JUDGE ORR ROAD
COMMERCIAL PARK
PRELIMINARY GRADING PLAN

SHEET 2 OF 2

JOB NO. 25315.00

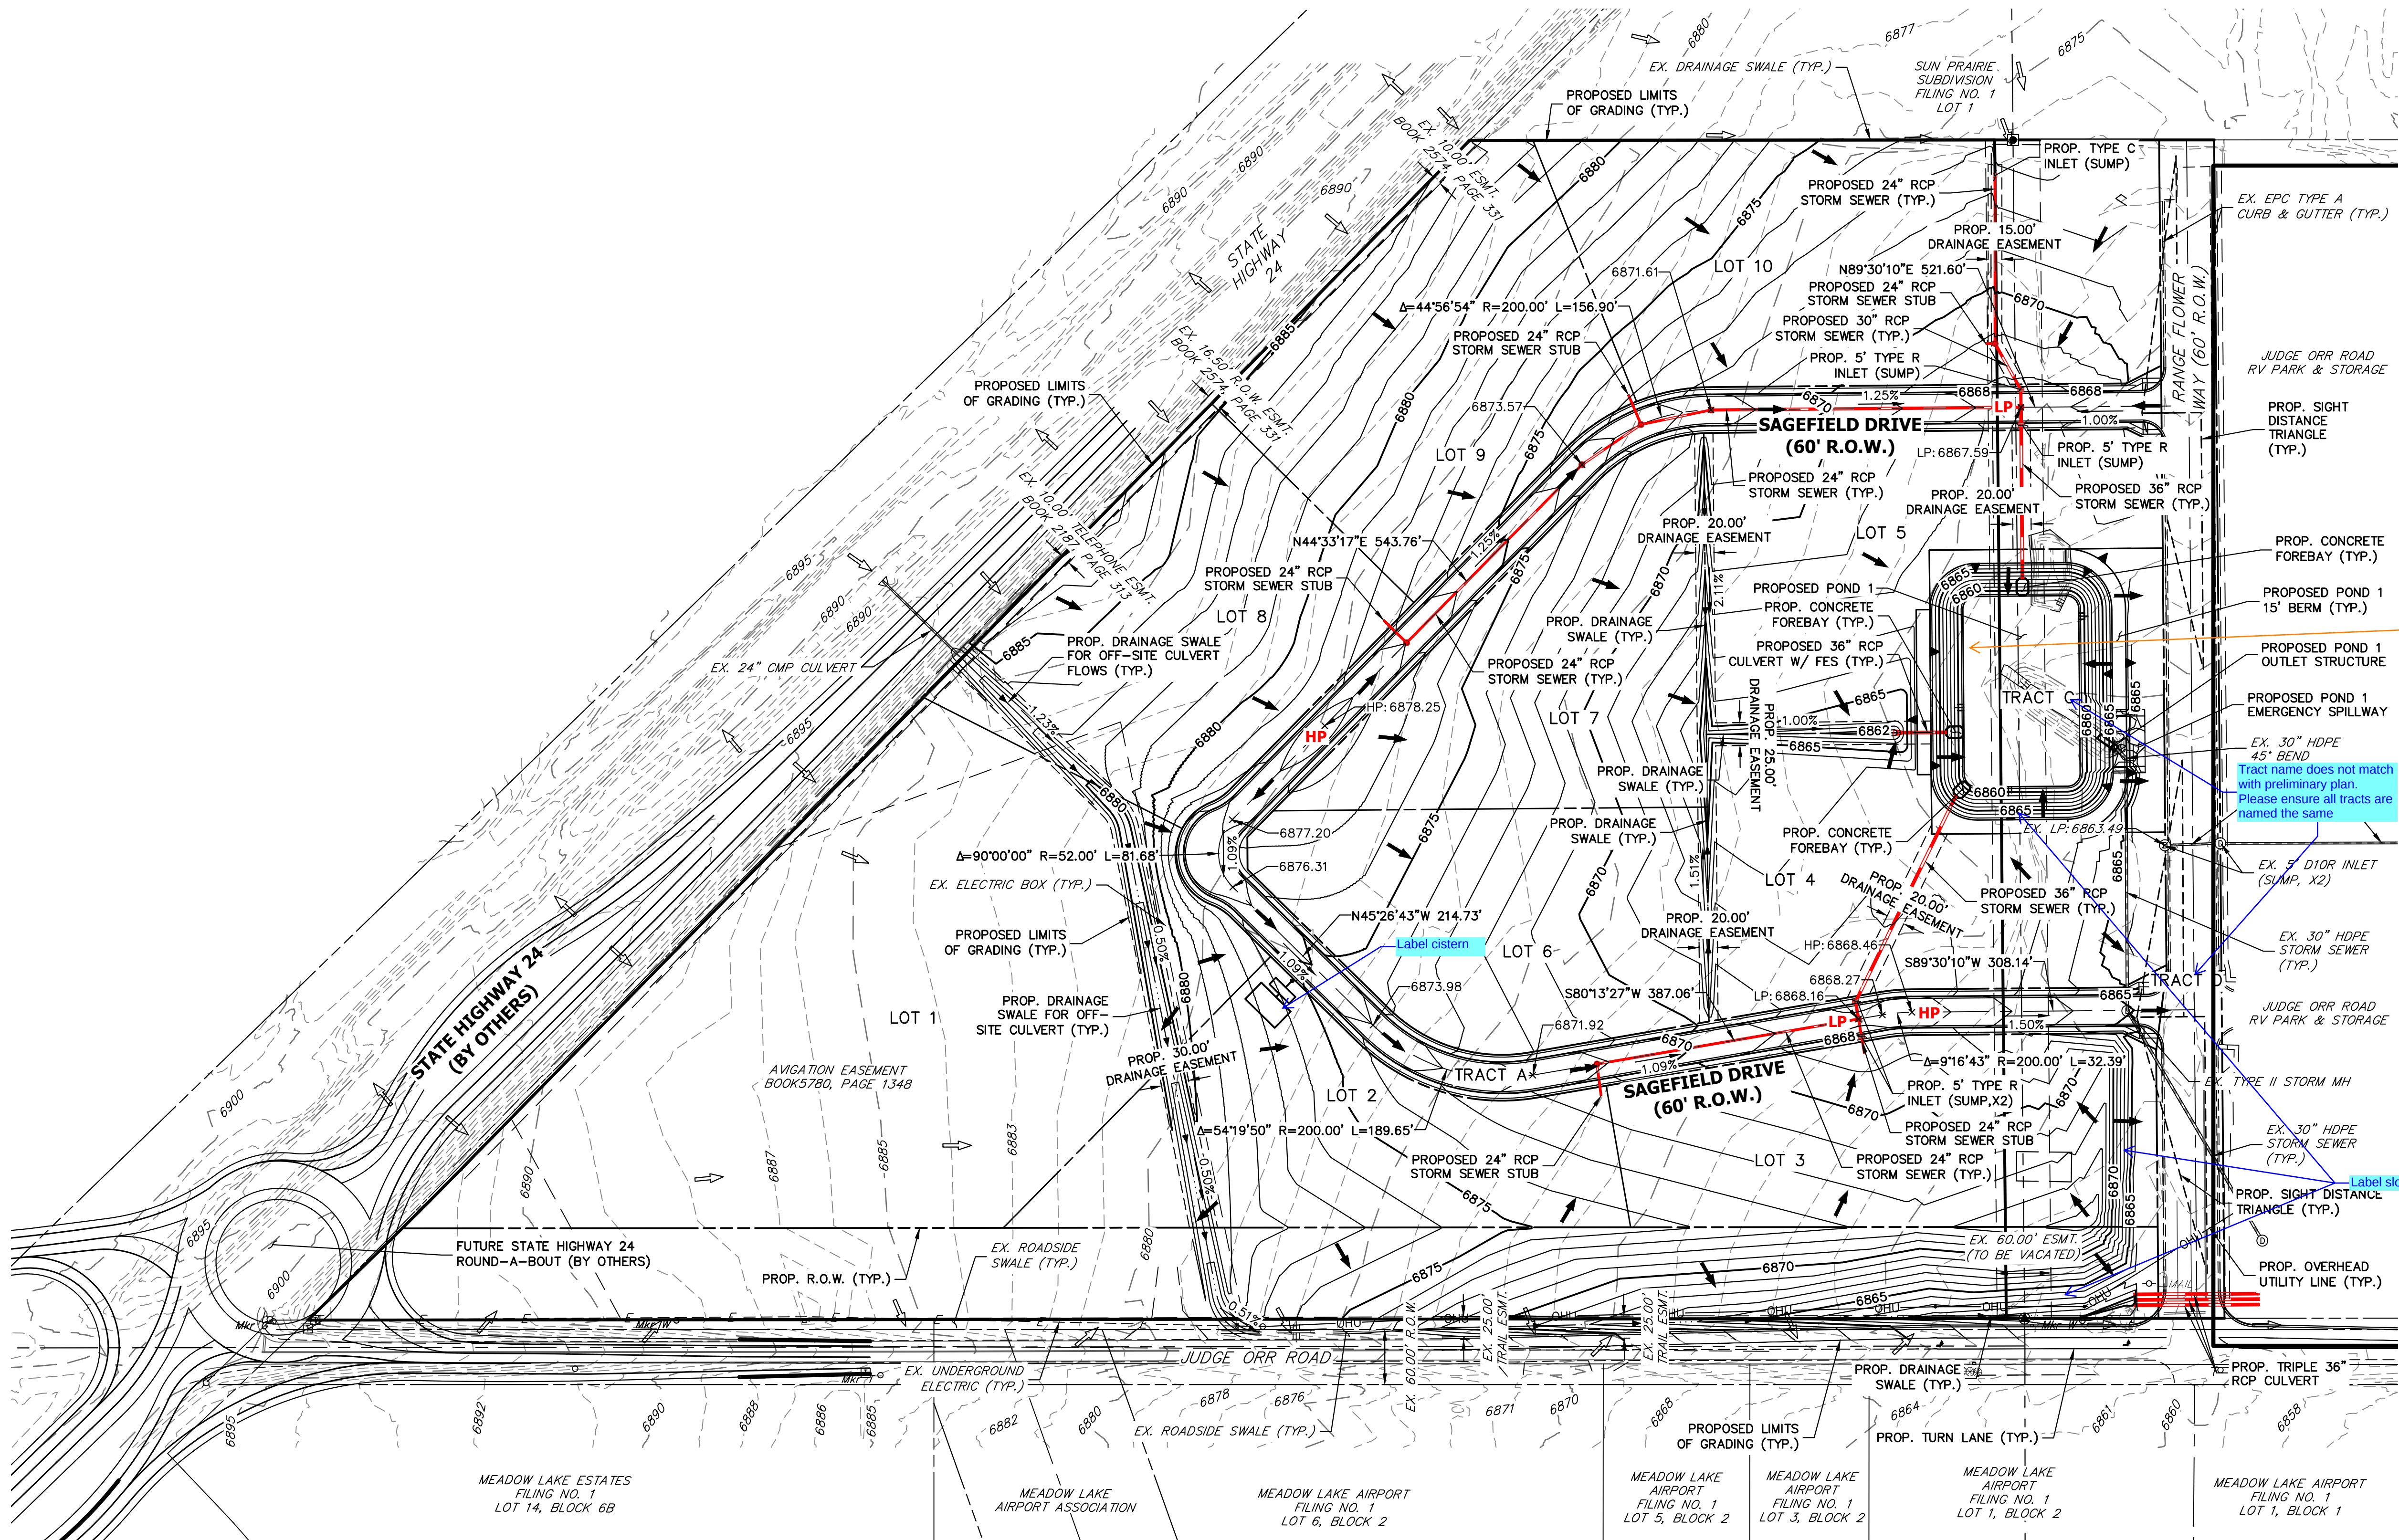
TB3 had groundwater levels at 15' and redoximorphic features were observed at 5' at TP2 nearby, which indicates the water table periodically rises to that level. There is 9 ft of cut at the ponds West side.

The soils report recommends to mitigate during construction but in the interest of avoiding a redesign during construction I would recommend installing a monitoring well at the pond location to observe the groundwater levels over the next year or two, and to adjust the design if necessary. It would also be worthwhile to provide the pond lining details in the design so they can be referenced in construction if it is determined it's necessary. We have go-bys for the pond lining that I can send over if you'd be interested in seeing those.

I have personally inspected a handful of ponds nearby in the 4-Way Ranch and Meridian Ranch area that have groundwater seeping into the pond that are causing significant (and costly) maintenance issues, and since there isn't much that can be done post-construction I highly recommend addressing this during design.
